# UNITED STATES PATENT AND TRADEMARK OFFICE

APPLICATION NO.	FILING DATE	FIRST NAMED INVENTOR	ATTORNEY DOCKET NO.	CONFIRMATION NO.
09/678,025	10/04/2000	Toru Koizumi	35.C14850	5647

**Office Action Summary**

FIG. 21

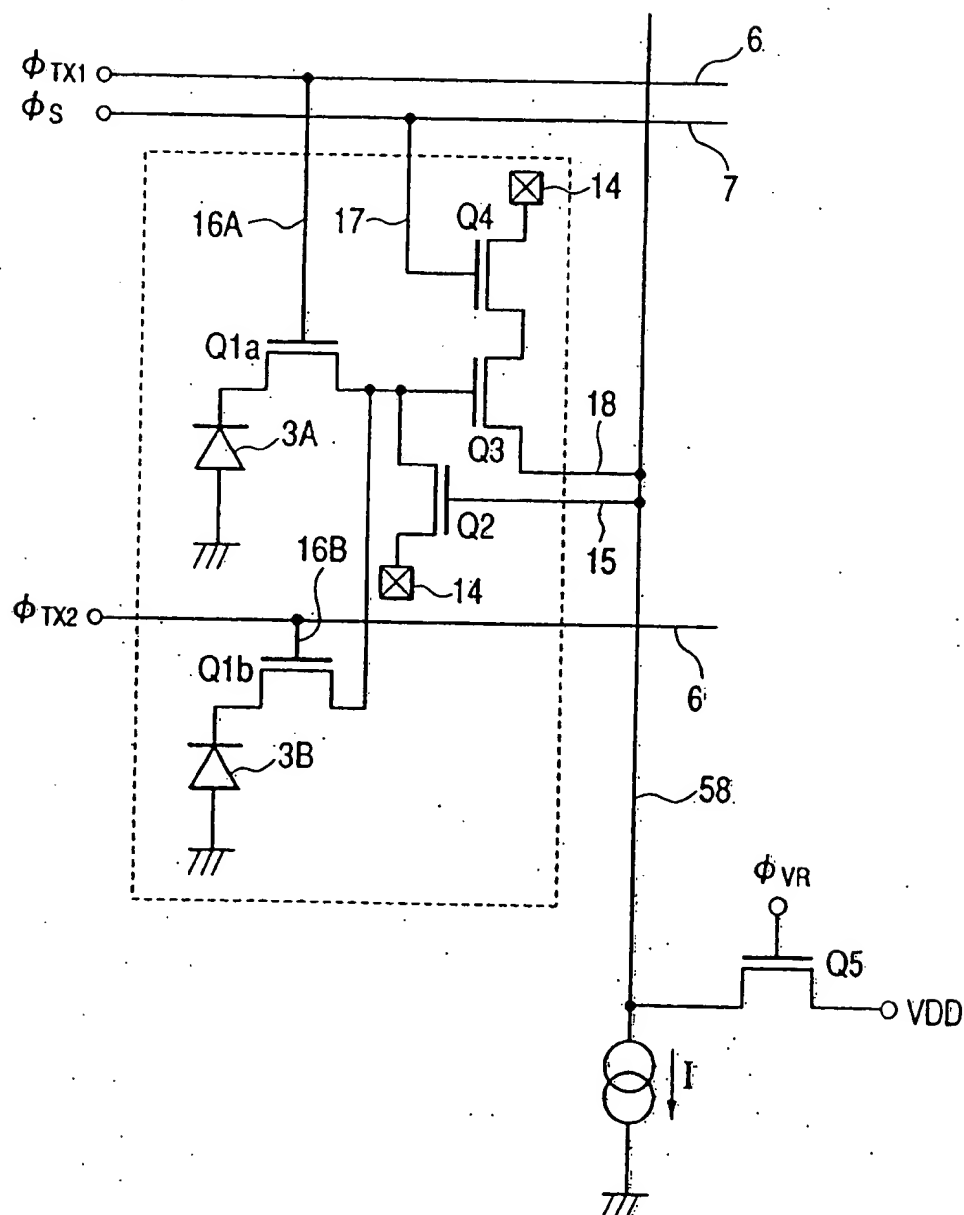
Approved  
CK  
10/12/05

FIG. 23

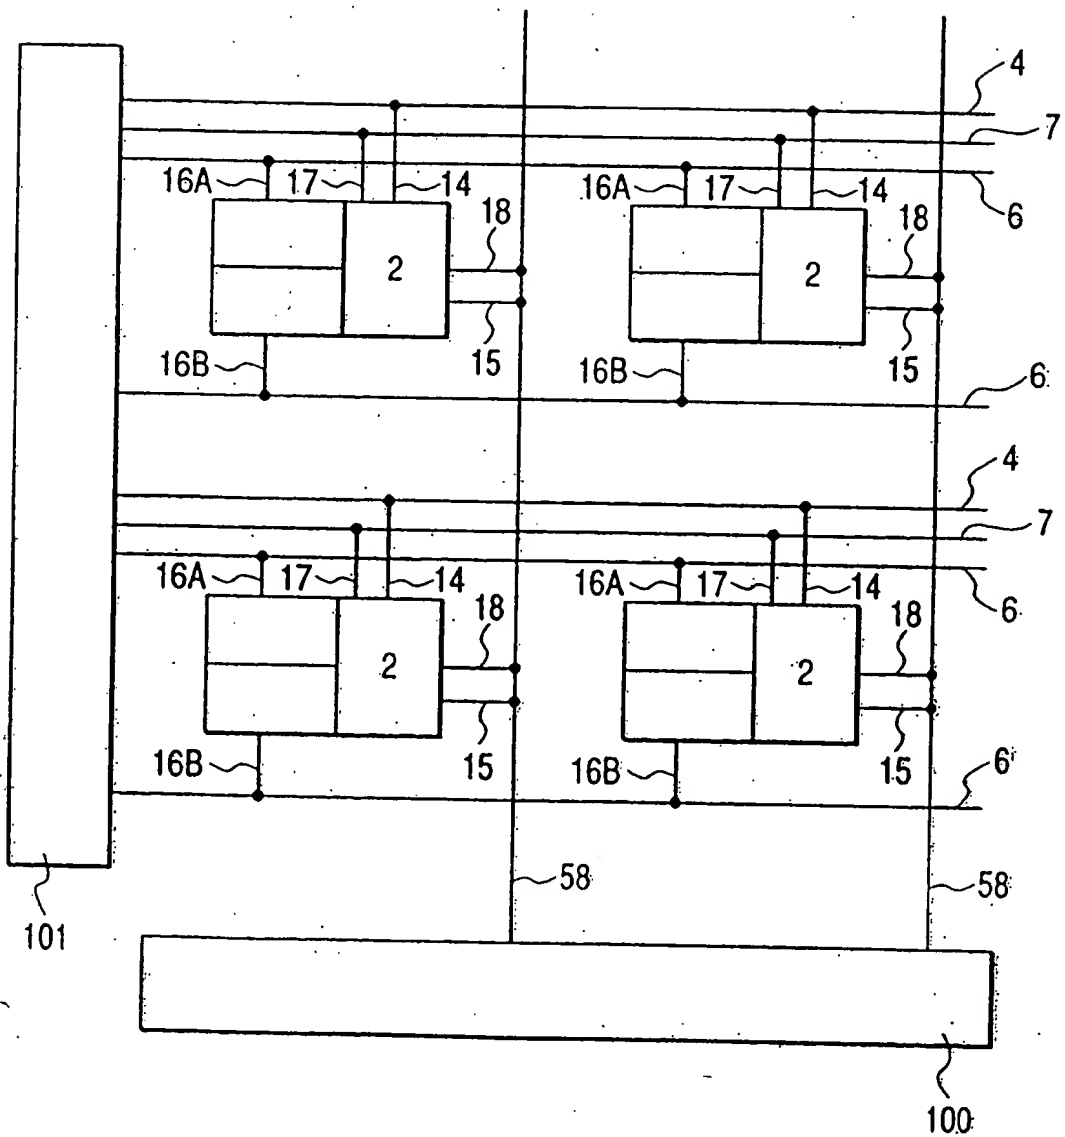
Approved  
10/12/05
